CITY OF PORTLAND BUILDING PERMIT

Job ID: 2012-04-3711-ALTCOMM

has permission to Replace rear deck & add deck dormer to 4th Floor of Unit #8
provided that the person or persons, firm or corporation accepting this permit shall comply with all of the provisions of the Statues of Maine and of the Ordinances of the City of Portland regulating the construction, maintenance and use of the buildings and structures, and of the application on file in the department.

Date
 26 APRIL 2012
 Scale
 1/4" = 1'-0"
**FIRE DOOR AT
 SECOND FLOOR
 STAIR**

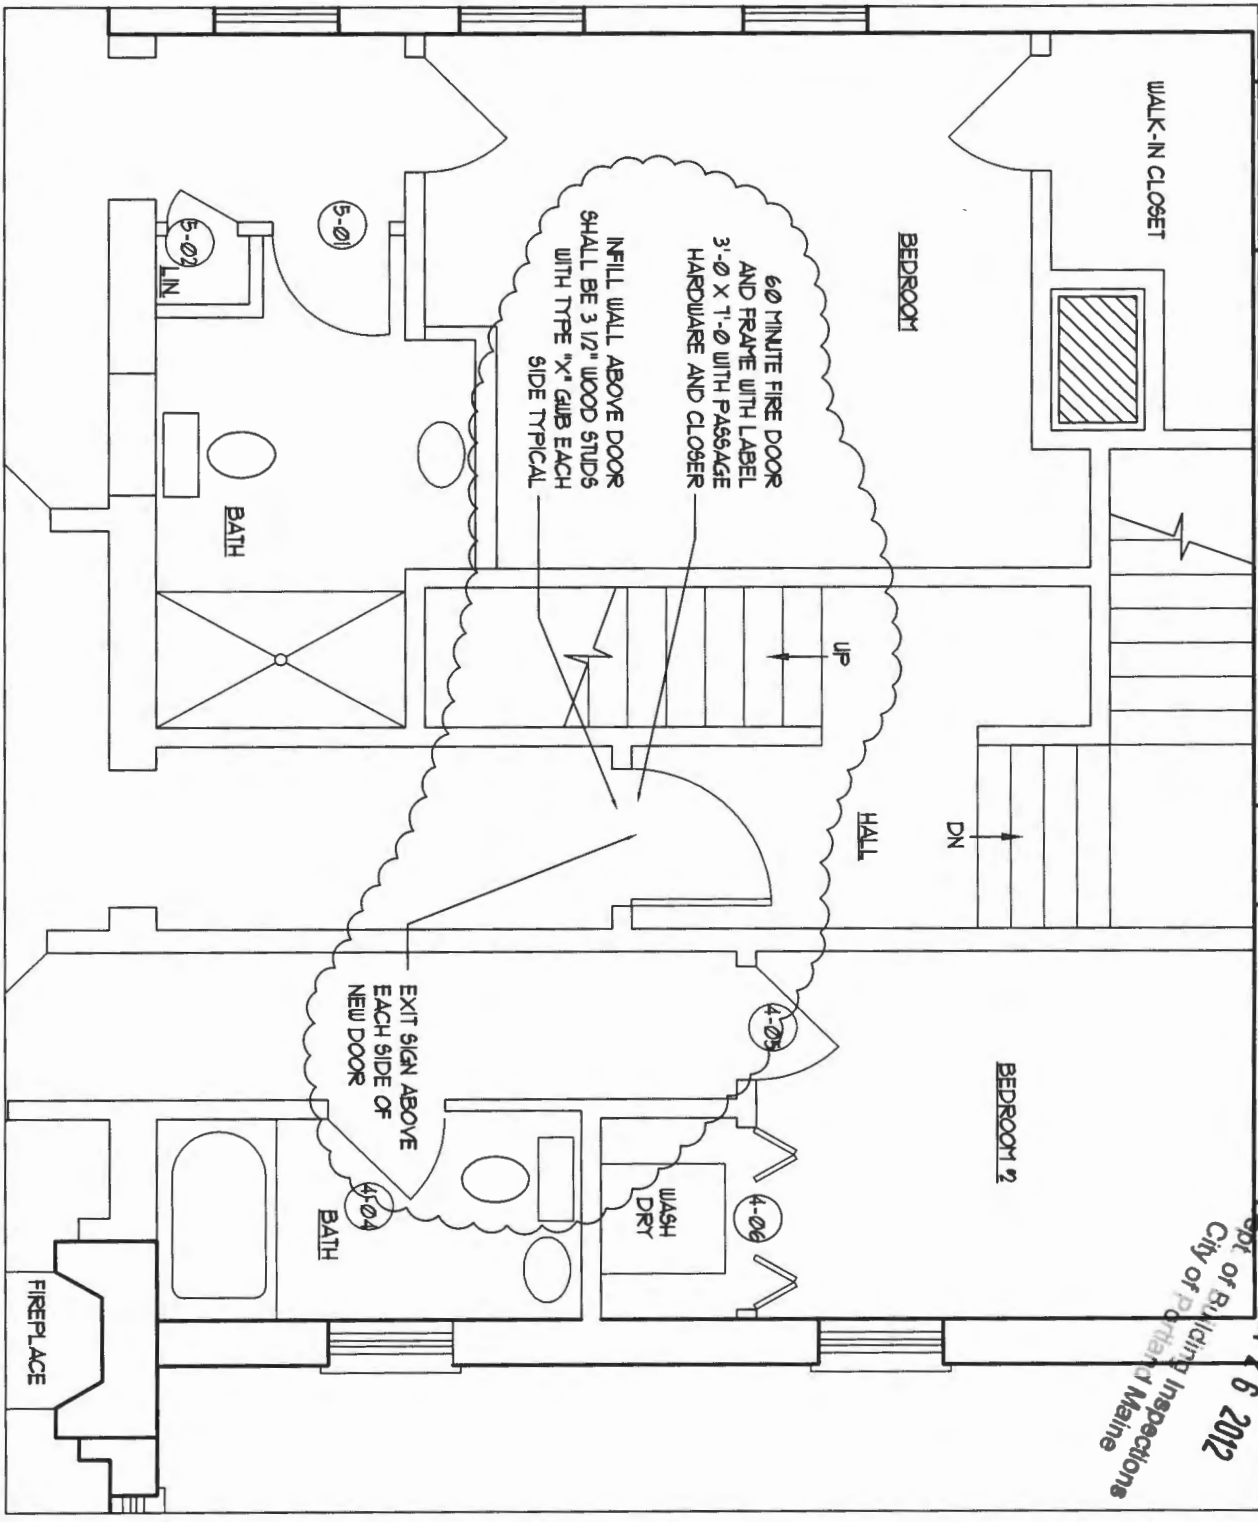
See the attached sketch for the added door. Tom is OK with adding this between the existing stairs. Per our conversation earlier no changes are required to the roof dormer. Structural drawings are being emailed to you from Aaron Jones.
